DART SERVICE INSTRUCTION

TO AMEND INSTRUCTIONS FOR CONTINUED AIRWORTHINESS ICA-D350-600 REV. 4

REF. CANADIAN STC: SH93-88

REF. FAA STC: SR00098NY and SR00099NY

SECTION 'L-L' UPPER HINGE ASSEMBLY

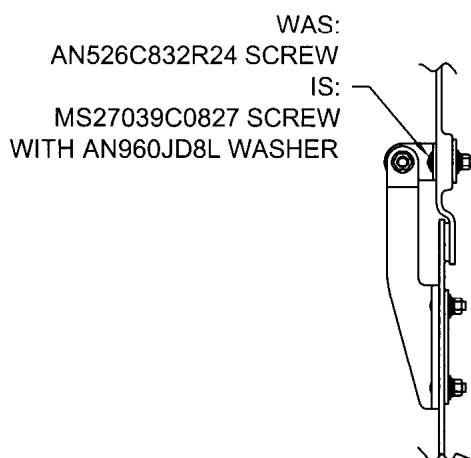
For the D350-600-241/-242 Spacepod™ Kits B/N 33438, 33439, 35395, 35396, 35397 and 35398, the AN526C832R24 screws that fasten the D3538-1 hinges to the Spacepod™ body have been replaced by MS27039C0827 screws with AN960JD8L washers. Section 'L-L' of Figure 10 should be updated as shown below.
